**Applicant: Reasoner**  
**SN: 09/115,764**  
**Group: 3682**

**Teichert (U.S. Patent No. 5,339,783)**

Modified Exhibit

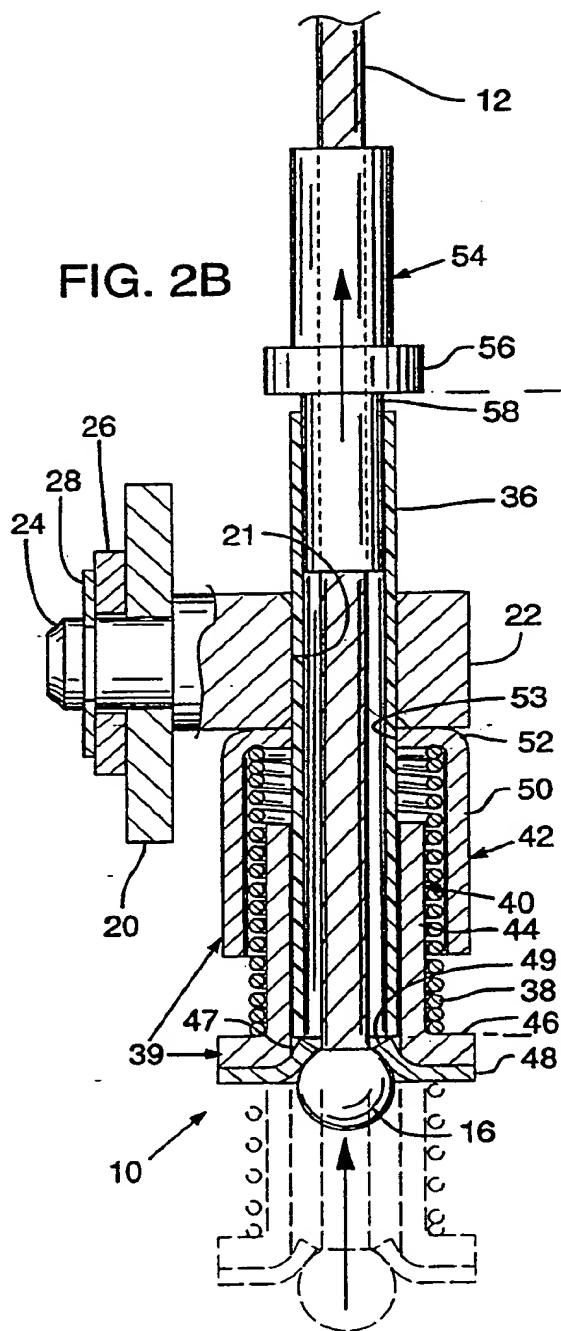
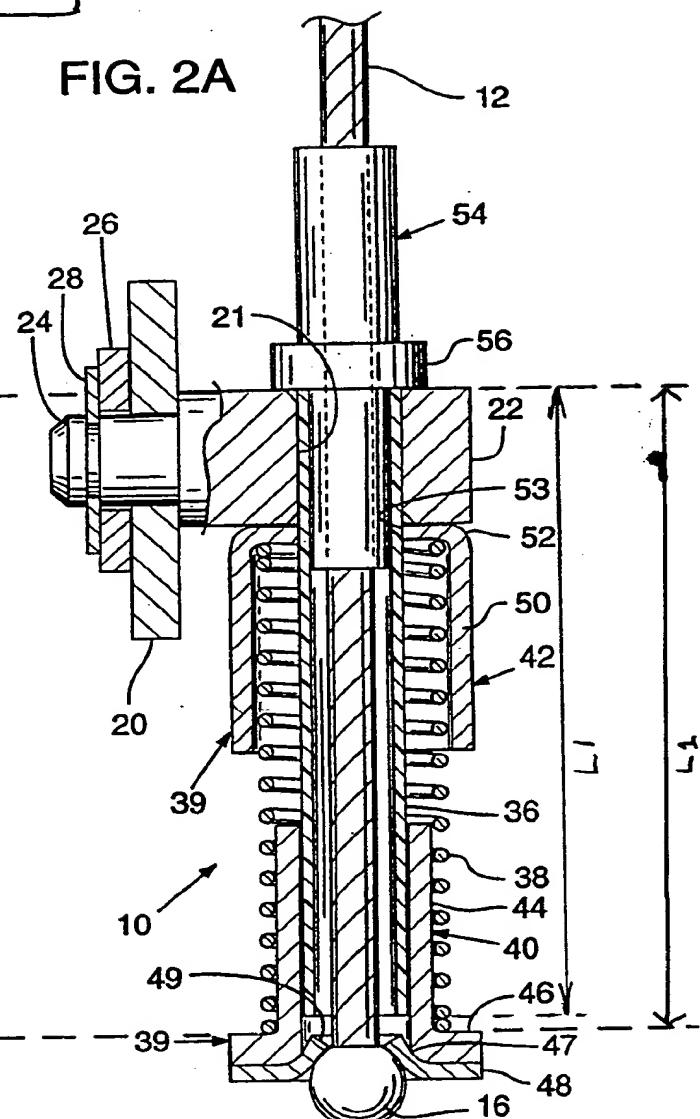
Similarly, since the fitting 54 and the stop 16 are both secured to the cable 12, the distance between the guide 40 and the fitting 54 can never change. The Examiner has referenced Figure 2a and 2b of Teichert. Although the drawings are not necessarily drawn to scale, the Examiner has made a mistake in measuring the drawings. Referring to the Examiner's Exhibit, the Examiner has drawn distance L1 too short--the Examiner did not draw L1 to extend all the way to the same point on the guide 40 as he did in Figure 2b. Rather, as shown on the attached modification of the Examiner's Exhibit, the Examiner mistakenly shortened the distance L1 to exclude the last coil in this spring of Teichert in Figure 2a. This apparently resulted in the Examiner measurement that the distance L1 was shorter than the distance L2, when in fact the distance between the guide 40 and fitting 54 ***does not and cannot*** change

between Figure 2A and 2B.

Applicant's modification of the Examiner's exhibit is attached. The elements 40 and 54 from Fig. 2A have been cut out and placed adjacent the same elements in Fig. 2B. As is clear from this exhibit, the distance between the components does not change.
